# SERVICE BULLETIN

SB No. 145 Issue No. 1

**TITLE** INSPECTION AND REPLACEMENT OF CENTRING ROLLER RETAINING RIVET WITH PIN

NUMBER 32-18 ISSUE 1

Figure 1 Nose Leg Assembly

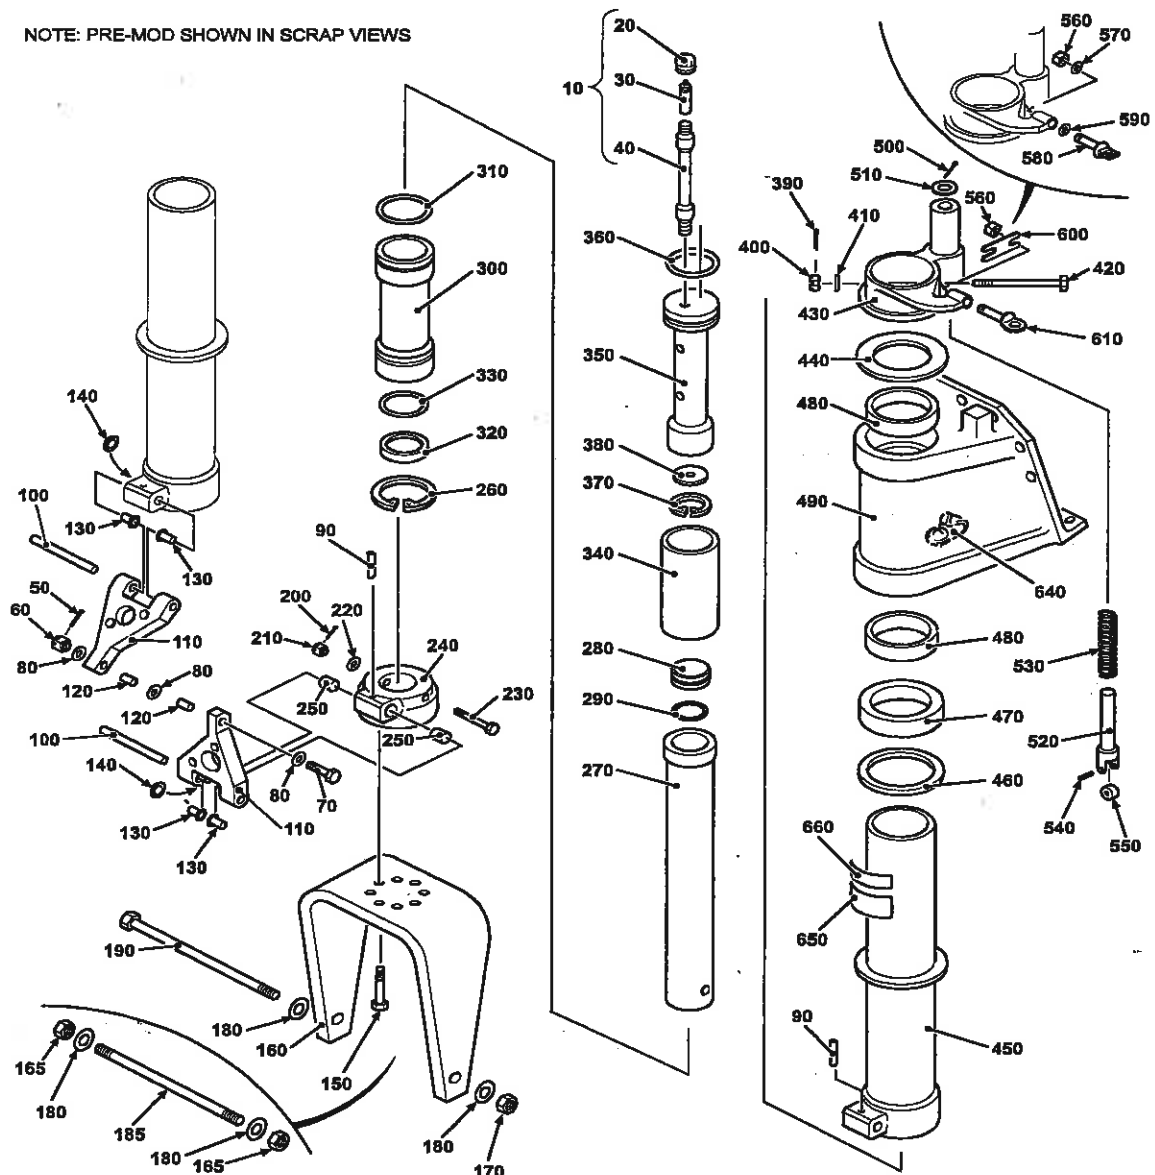
There have been occurrences of excessive wear to the rivet that secures the roller to the plunger of the nose leg centring mechanism.

The replacement of the rivet that secures the roller to the plunger of the nose leg centring mechanism with a pin of harder material..

- a. Refer to Fig 1. With maintenance clip removed lightly compress the spring (530) and remove split pin (500) and washer (510). Release spring tension and remove spring (530) and plunger (520) from steering adaptor (430).

- b. Using a drill (dia 0.131 in) and suitable punch carefully remove the rivet (540). Make sure not to damage bore in plunger (520) or roller (550).
- c. Fit roller (550) to plunger (520) using new pin Part No 64835-82. Using Swaging Tool Part No FHQ3294 swage both ends of pin to form a countersunk head. Make sure ends of swaged pin do not protrude above the outside face of the plunger fork end. Carefully remove any protrusion with a file.

- d. Using Check Gauge 5009-01-A17 (Go/No Go) check gap between bottom of roller (550) and adjacent face of fork of plunger to make sure pin is not bent after assembly swaging operation. Check by hand that the roller can be freely rotated and that there is no binding or obvious restriction.

NOTE: PRE-MOD SHOWN IN SCRAP VIEWS
